PROJECT: TROPICAL DURANGO PARK - PHASE II

CITY OF LAS VEGAS INTER-OFFICE MEMORANDUM			DATE: March 16, 2011	
TO: Land Development Services Department of Public Works			FROM: Albert Sung, P.E. Flood Control Project Engineer Department of Public Works	
SUBJECT: Drainage Study for: Tropical Durango Park – Phase II			COPIES TO: Stanley Consultants	
Cross Streets:		NWC of Tropical Pkwy. & Durango Drive		Architectural Services, Patrick Batte City of Las Vegas
File Number:		F:\Depot\DSMemos\DS4517B.doc		Bart Anderson, P.E., DevCo
Parcel Number:		125-29-601-021		CCPW
Zoning Action:		SDR-39771		
FEMA Flood Zone		YES	NO X	
Proposed Storm Drain		YES X	NO

TECHNICAL DRAINAGE STUDY UPDATE, ADDENDUM 1 for TROPICAL DURANGO PARK: PHASE II

Subject: Technical Drainage Study Update, Addendum 1, for Tropical / Durango Park Phase II, City of Las Vegas File Number DS4517A.

Cross Section for Update-Sect W (B) Tropical - pre-berm

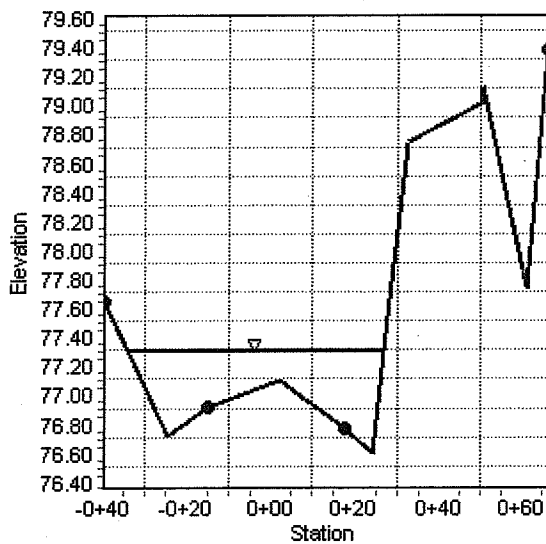
b) The 100-year normal depth in Section W (B) in the existing condition is shown to be 1.74' which is hugely different from the other two sections. Correct in the next submittal.

The section was copied from the approved study; however, it appears that the section had incorrectly included a 75.5 ft elevation point on the north side of the road. The section was revised and the new calculation is included. The normal depth decreased to 0.7 ft. Because the error affected only a very small part of the overall cross sectional area, the water surface

elevation, 77.3 ft, did not change, and thus, the proposed improvements to Tropical will, as shown in original submittal, decrease the water surface elevation at this location.

Normal Depth	0.70	ft
Elevation Range	76.60 to 79.37	ft
Flow Area	23.39	ft ²
Wetted Perimeter	61.42	ft
Hydraulic Radius	0.38	ft
Top Width	61.31	ft
Normal Depth	0.70	ft
Critical Depth	0.85	ft
Critical Slope	0.00788	ft/ft
Velocity	5.60	ft/s
Velocity Head	0.49	ft
Specific Energy	1.19	ft
Froude Number	1.60	
Flow Type	Supercritical

Cross Section for V-Notch Weir - Sidewalk @ SW corner of Park

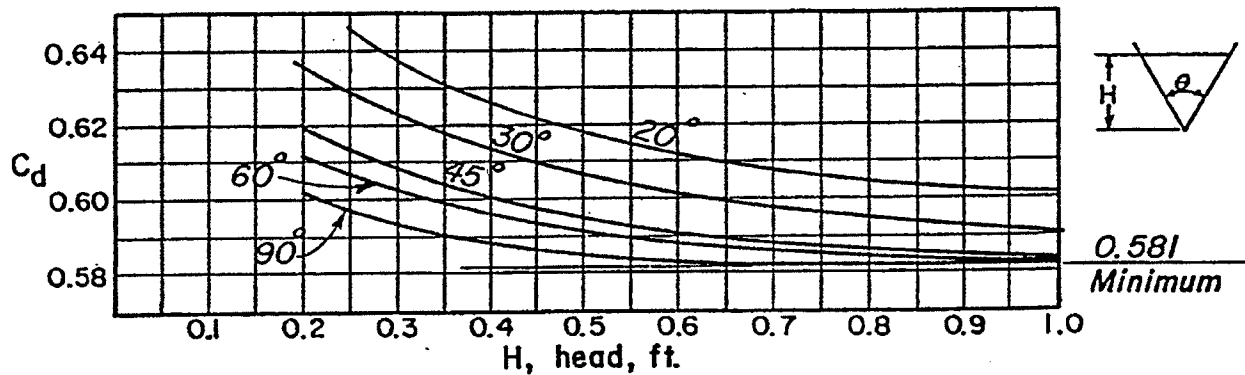
d) Address what the straight line running from "87.OFG/HP" to "74.4OFG" is? According to the contour lines, this line appears to be a flow line in the upper half but turns to a ridge line in the lower half. A culvert is required if this line indeed discharges at the sidewalk confluence. Address and resolve in the next submittal.

The line was removed from the plan. It was included in Phase 1 to describe to the contractor how the grass area should be sloped. The grading for this area was completed with Phase 1 construction, and the slopes of the grass area are now shown as existing contours. The grass area is basically flat and stormwater from minor events is expected to infiltrate into the soil.

During the 100-year storm event, flow will weir over the sidewalk. The flow from the 100-year event is 6 cfs (referenced from the Ultimate Condition of the approved study for Phase 1, sub-basin C-PARK). The sidewalk is essentially a v-notch weir with an angle less than 175 degrees. The depth of flow is less than 0.5 ft; velocity is less than 2 ft/sec; thus, depth times velocity is well below the 6 ft²/s minimum allowed. Therefore, neither a culvert nor sidewalk underdrain is required.

Headwater Elevation	1.41	ft
Headwater Height Above Crest	0.41	ft
Tailwater Height Above Crest	0.00	ft
Flow Area	3.79	ft²
Velocity	1.58	ft/s
Wetted Perimeter	18.64	ft
Top Width	18.62	ft
